## Remote Control Handle Change - P/N 92744A2

Replacement curved handle P/N 92744A2 for 88688A-- Console Remote Control.

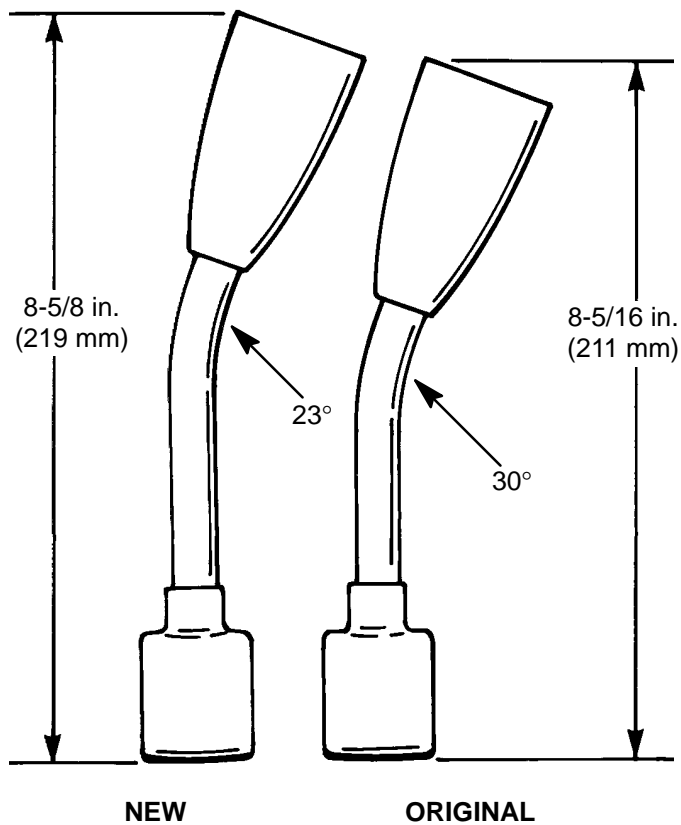
The original 30° bend replacement handle installed on the remote controls listed is not available. A new replacement 23° bend handle is available and is slightly taller than the original one. On Dual Console Controls, you may want to change both handles so they are the same height. The part number for the new handle is the same as the original handle part number.
